**BEFORE THE NEW PLYMOUTH DISTRICT COUNCIL**  
**INDEPENDENT HEARINGS COMMISSIONER**

**IN THE MATTER** of the Land Use Resource Consent  
LUC21/47890 application for  
1-3 Dawson St, New Plymouth

**STATEMENT OF EVIDENCE OF BILL JACKSON ON BEHALF OF THE GROUP OF  
OBJECTORS**

**11 August 2021**

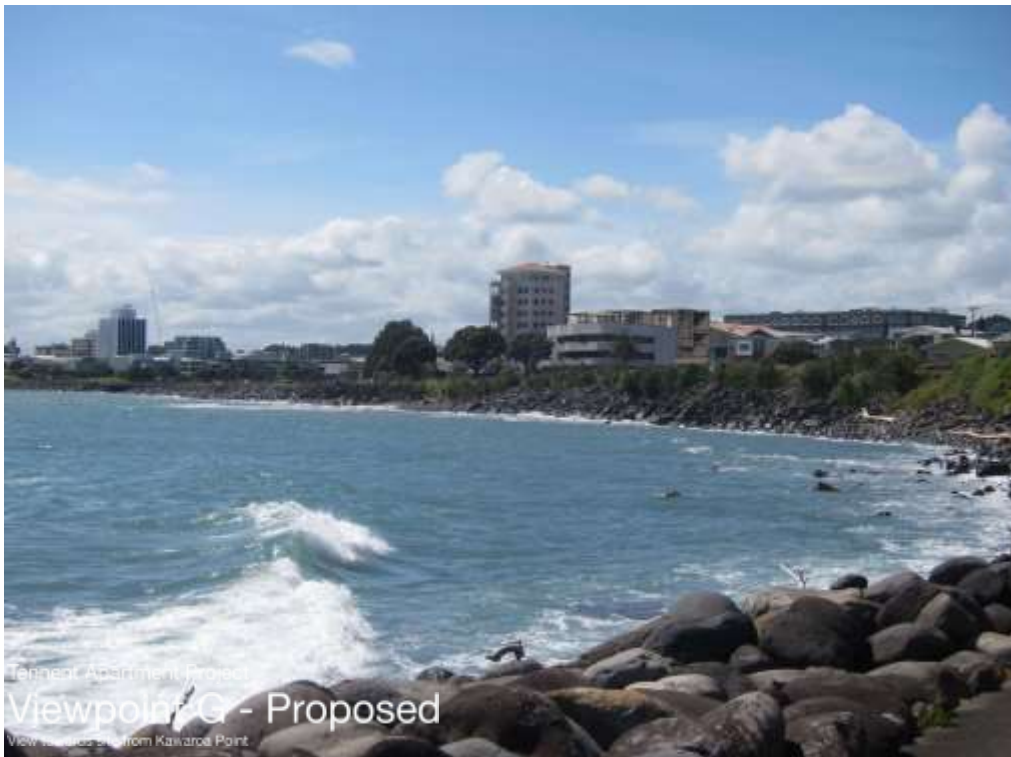
This view shows the true bulk of the proposed building.

In this view the foreground grey fence and pole are distracting from the true bulk of the proposed building. Applicant's assessment: **Very low**

The proposed building is showing as transparent, when in fact, glass will appear black, as it seen in the existing office building. It will appear heavier than it looks here.

My assessment: **Moderate adverse**

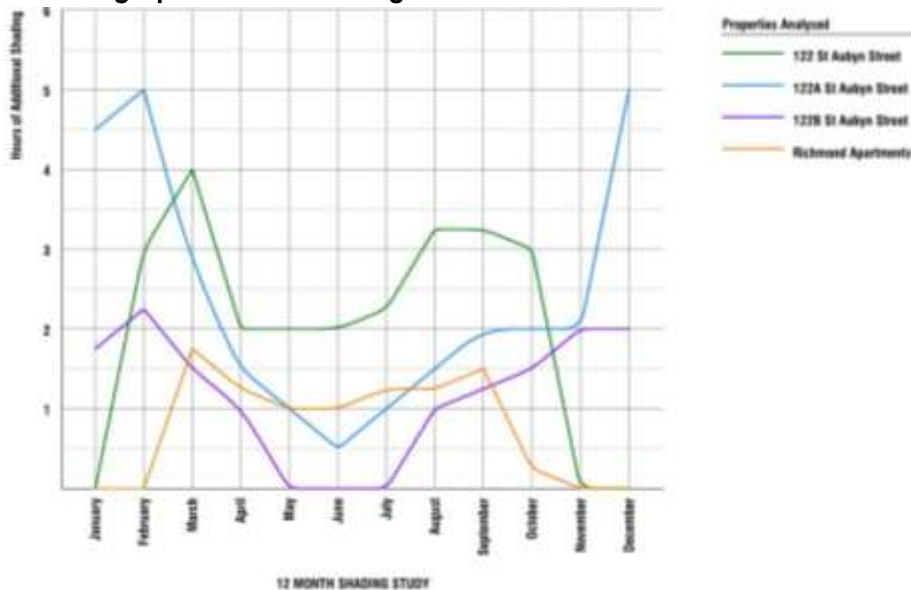
Firstly, I note that 'shading' is not listed in the ODP assessment criteria for Bus 13. While it is one way to assess the adverse effects on the character and visual amenity of the area, there are other adverse effects that should be equally considered: e.g. Loss of light, loss of safety, loss of privacy. Also the effects of shade on humans. (See Section 7)

The applicant's section 92 response, BOON drawings SK5.01 to 5.04 provide a useful summary of the **adverse effects** of shading on the objectors sites, for which I tabulate the duration and assess as follows:
